11th June, 1920

## REPORT ON THE KING RIVER DAM SITE

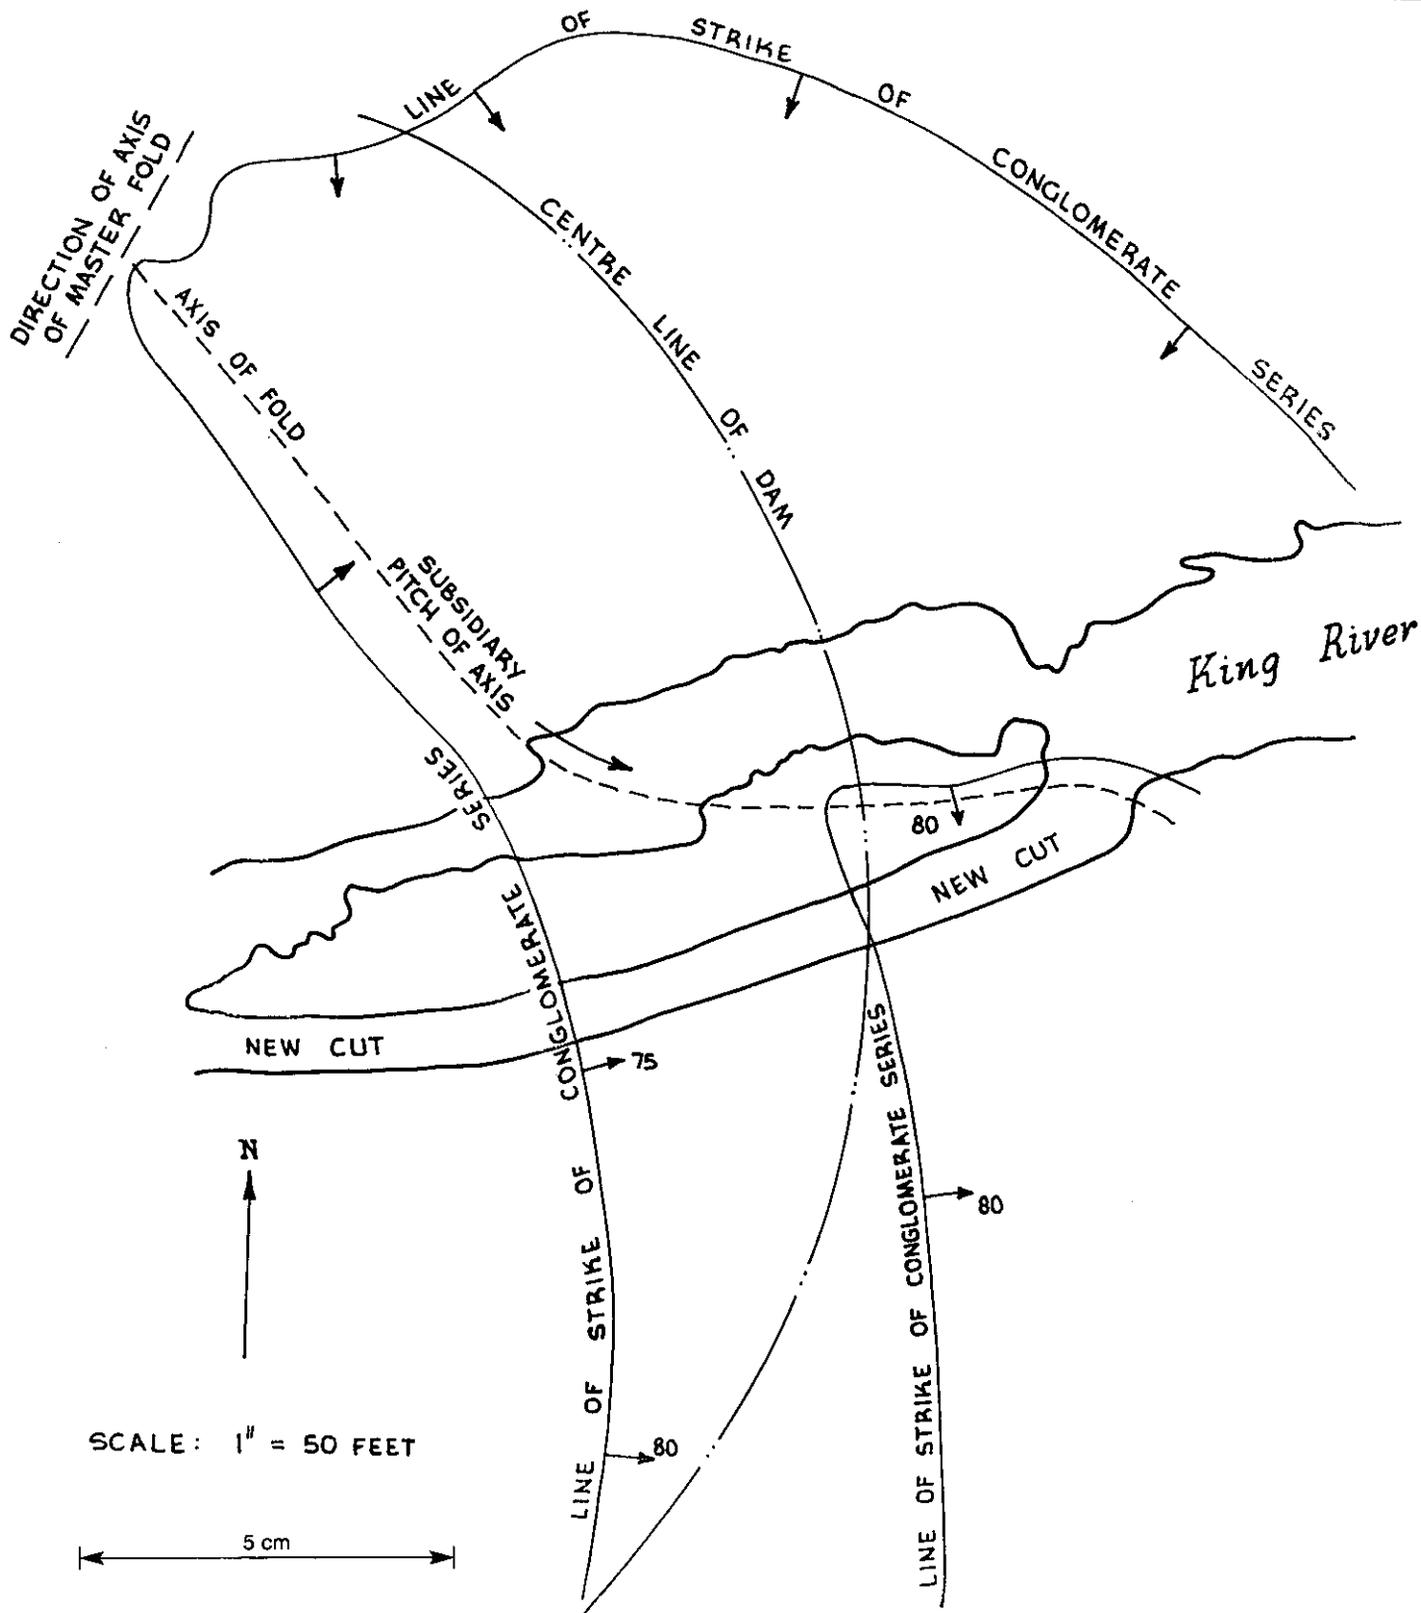
The geologic structure of the actual location of the dam is shown in the following plan.

The axis of the subsidiary fold runs approximately at right angles to the direction of the axis of the main overfold - the master fold - and pitches from the level of the top of the proposed dam to the river level as shown in the plan. That plan shows the relation of the curve of the dam to these axes. Obviously, the axis which has the greater effect on the strength of the foundation and abutments of the dam is the subsidiary axis. On the south side of the river the relation of the dip and strike to the curve of the dam is clearly such as to present very satisfactory conditions for foundation and abutments. From the middle of the river northwards to the north bank the dam crosses the axis of the fold at right angles and taking cognisance of the steep upward slope of the trough of the fold in a downstream direction thoroughly sound conditions for the foundation are presented. The remainder of the dam runs approximately at right angles to the strike of the beds, the dip of which is nearly parallel to the centre line of the dam and is directed upstream at about  $45^\circ$ . These conditions present satisfactory evidence of the suitability of this portion of the site for dam construction.

The structural geology is, therefore, favourable to the construction of a dam of the dimensions proposed.
